TO: Mercedes-Benz Dealer Principals, General Managers, Sales Managers, Service Managers, Parts Managers	FROM: Gregory Gunther, Senior Manager, Vehicle Compliance and Analysis, Engineering Services
RE: Service Campaign Launch Notification Rework Connector Assignment in Trunk Fuse and Relay Module MY22-23 SL (232 platform)	DATE: January 12, 2024

Rework Connector Assignment in Trunk Fuse and Relay Module

Campaign No.2023100003, October 2023

SUBJECT: **Model SL (232 platform)**
Model Year 2022 – 2023

Figure 5

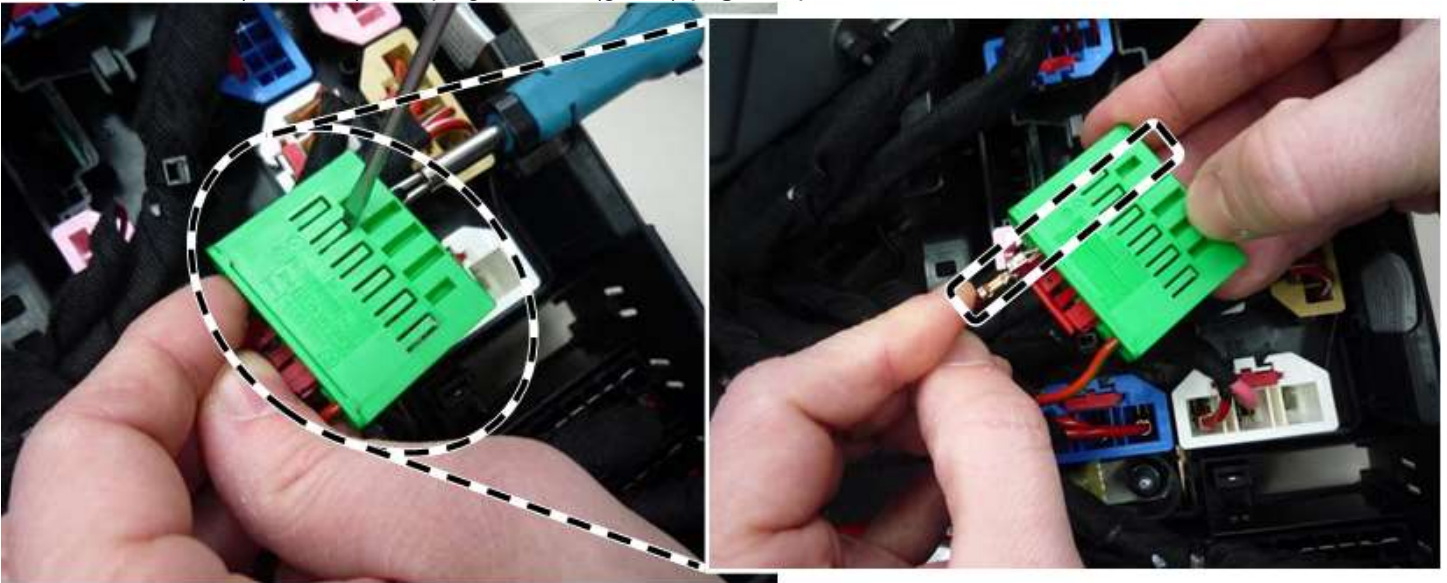
7. Disconnect line (red/black) from plug S1 **Pin2** (green) (**Figure 5**).

Figure 6

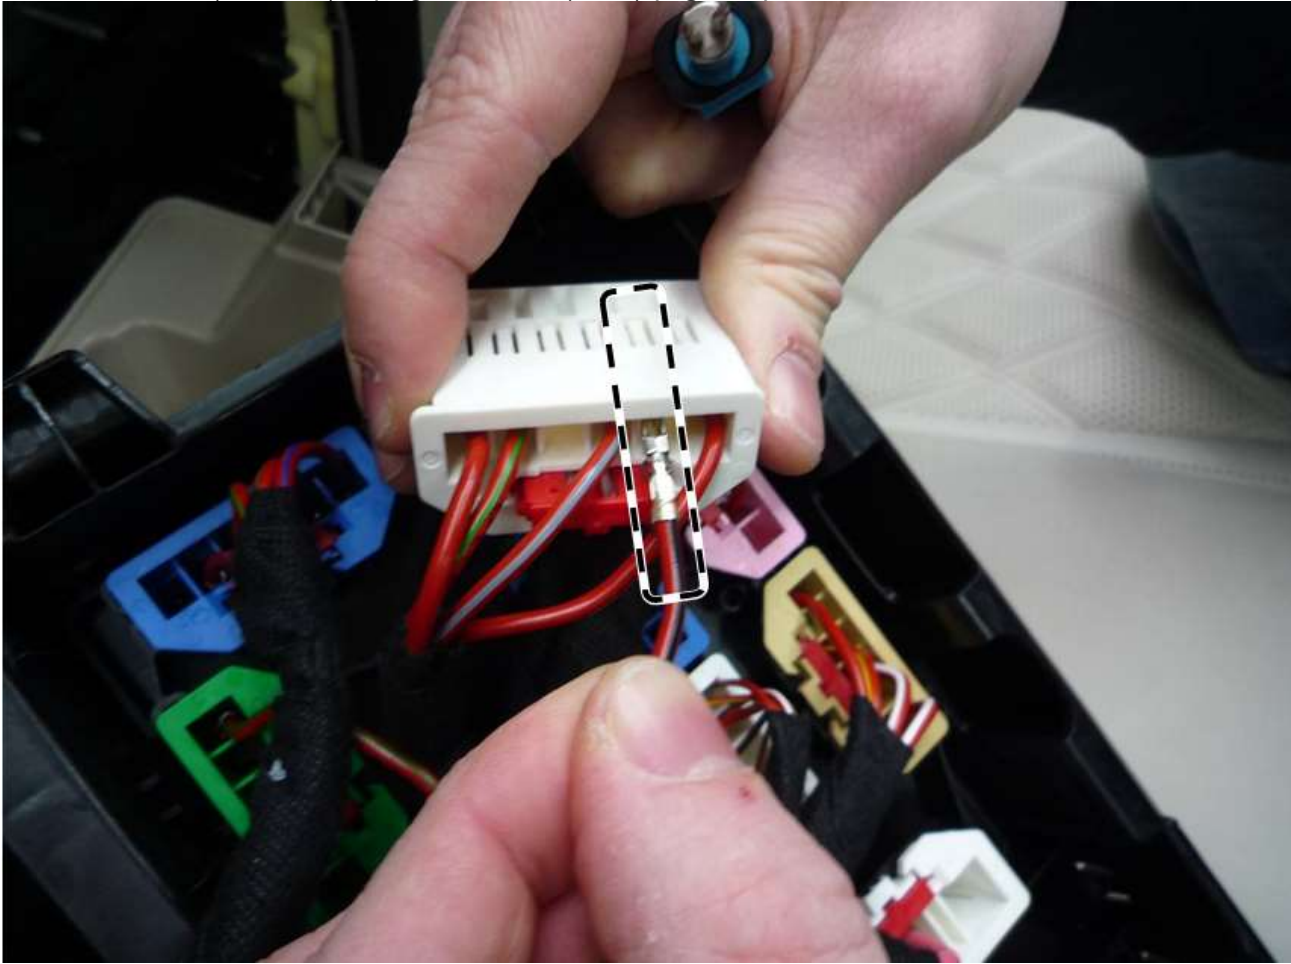
8. Relocate line (red/black) to plug S5 in **Pin5** (white) (**Figure 6**).

Figure 8

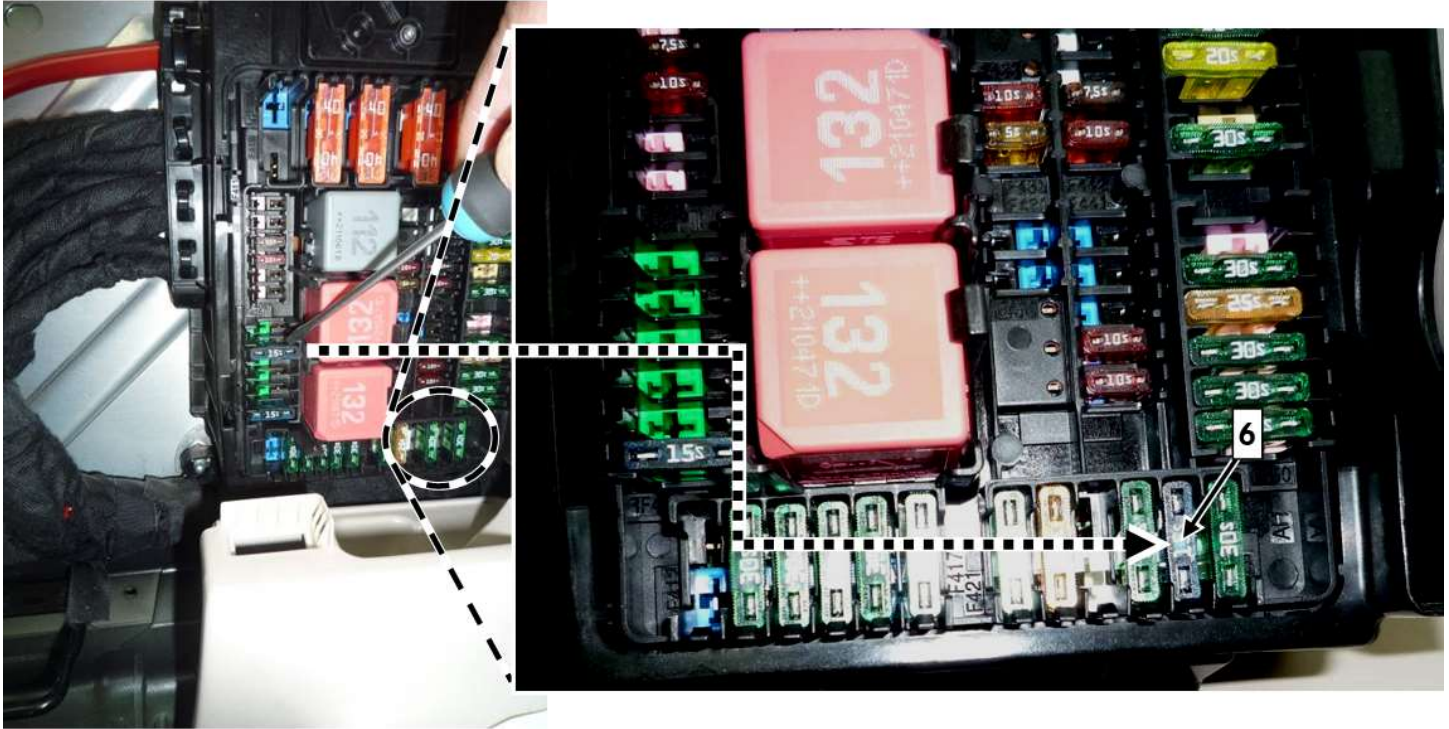
10. Re-locate blue 15 A fuse from slot F404 to F425 (6, Figure 8 and Figure 9).
